ADDENDUM NO. 1
TO
CONSTRUCTION DOCUMENTS
FOR PROJECT NO. E008282

DESCRIPTION: **AML SITE 1820, BUTTERMILK HIGHWALLS**

LOCATION: **PIKE COUNTY, INDIANA**

SITE NAME BUTTERMILK HIGHWALLS		SCALE 1" = 400'	TITLE SITE ACCESS
SITE NO. 1820	CONTRACT NO. E008-282	DATE 10/25/2017	DRAWN BY C.J.H.

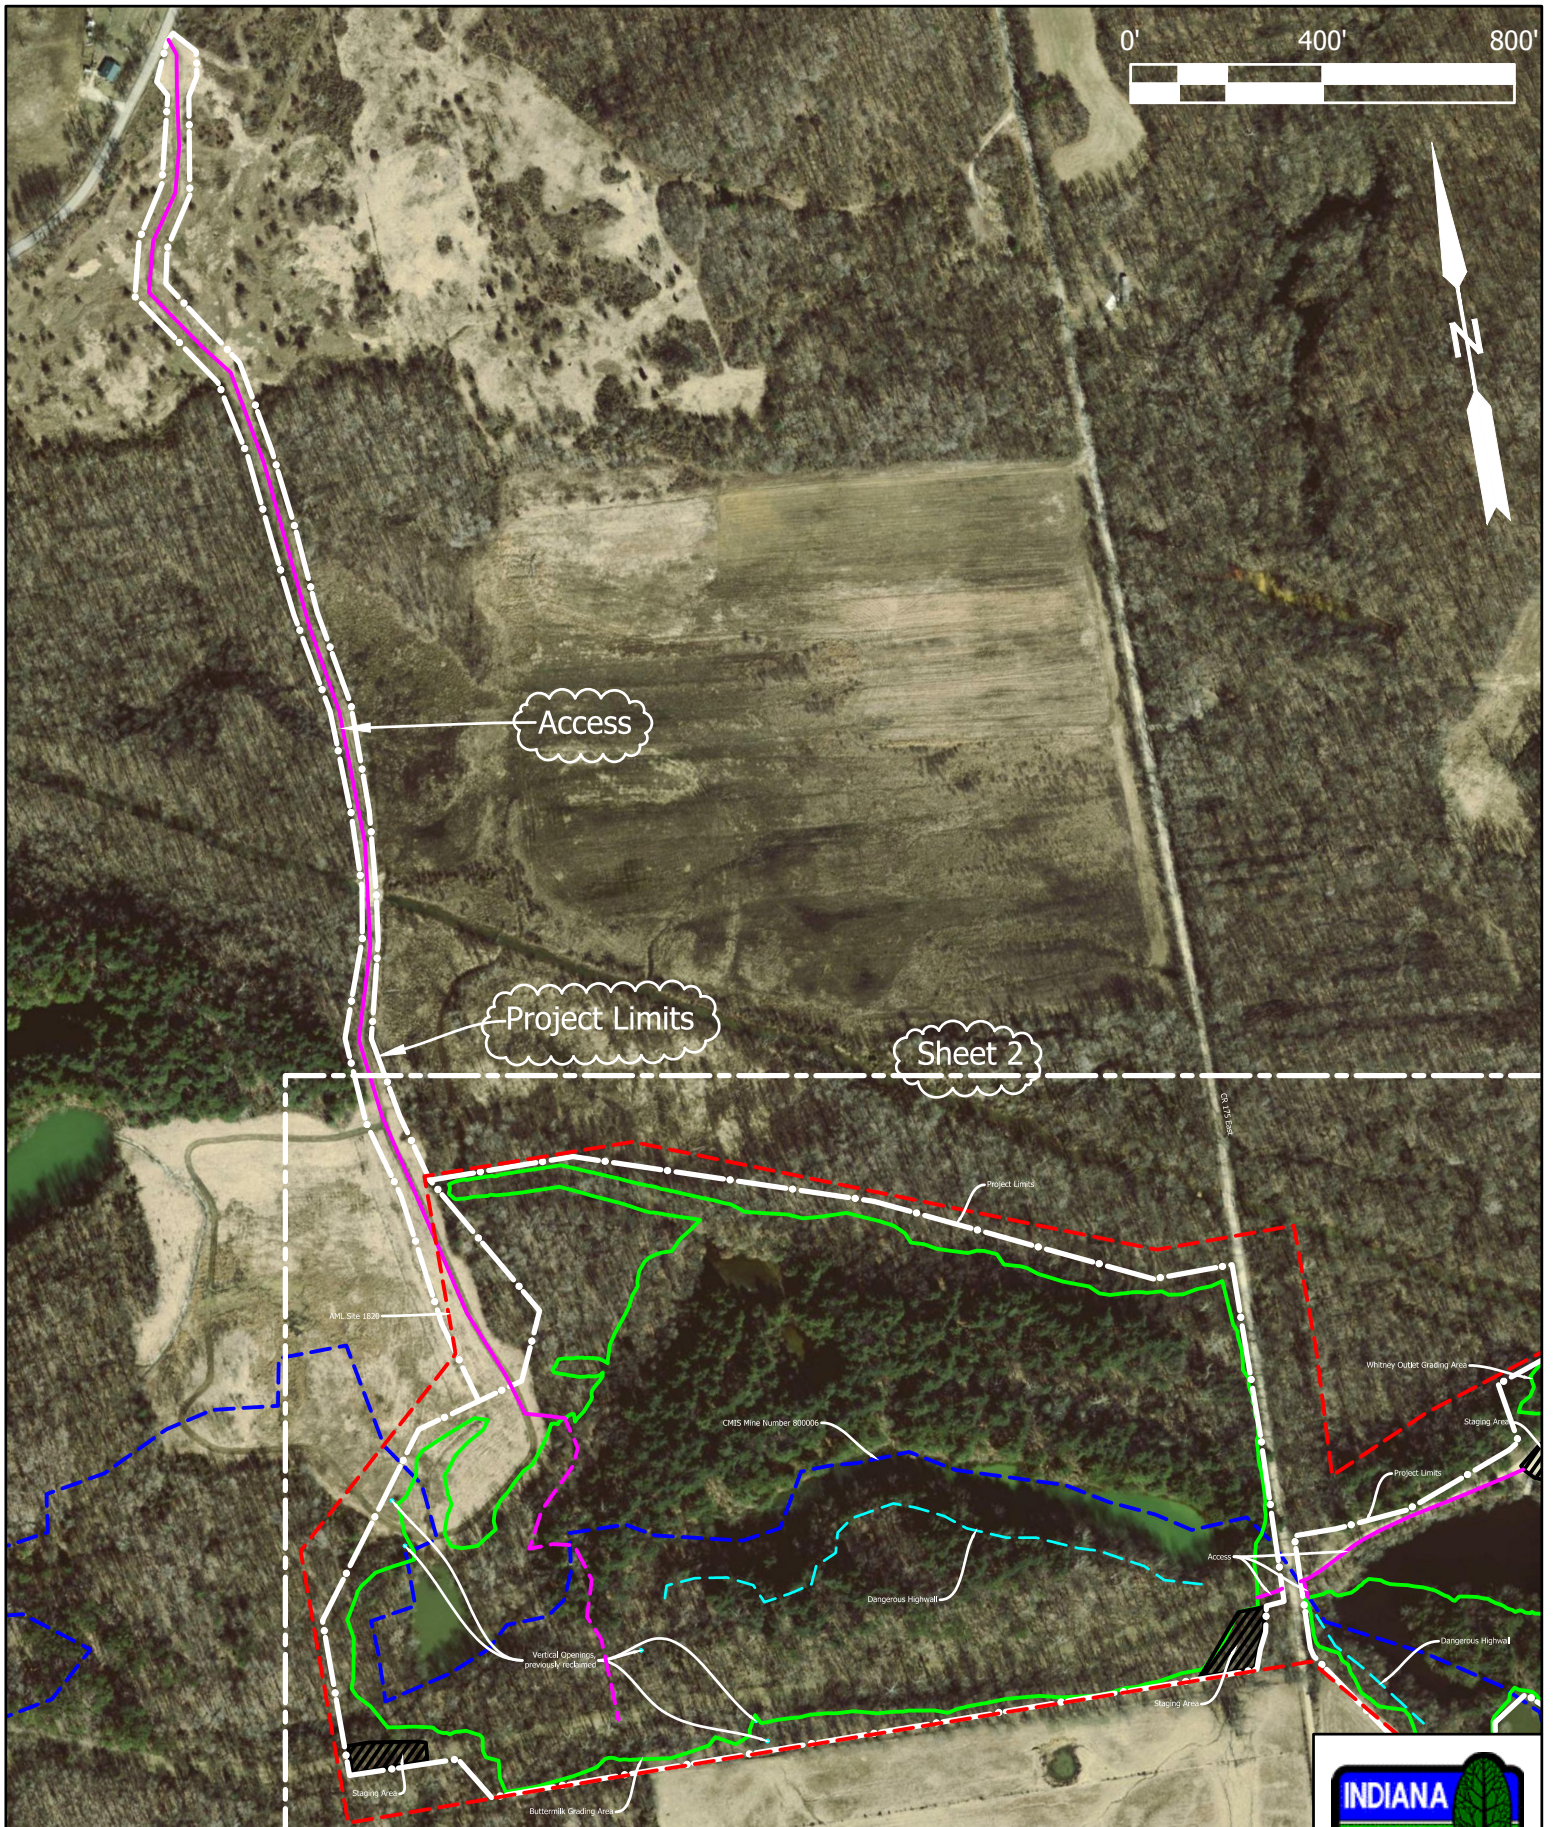
Insert into the plans the attached drawing titled "SITE ACCESS". This drawing expands the project limits to include a new access route for sheet 2 of the plans.
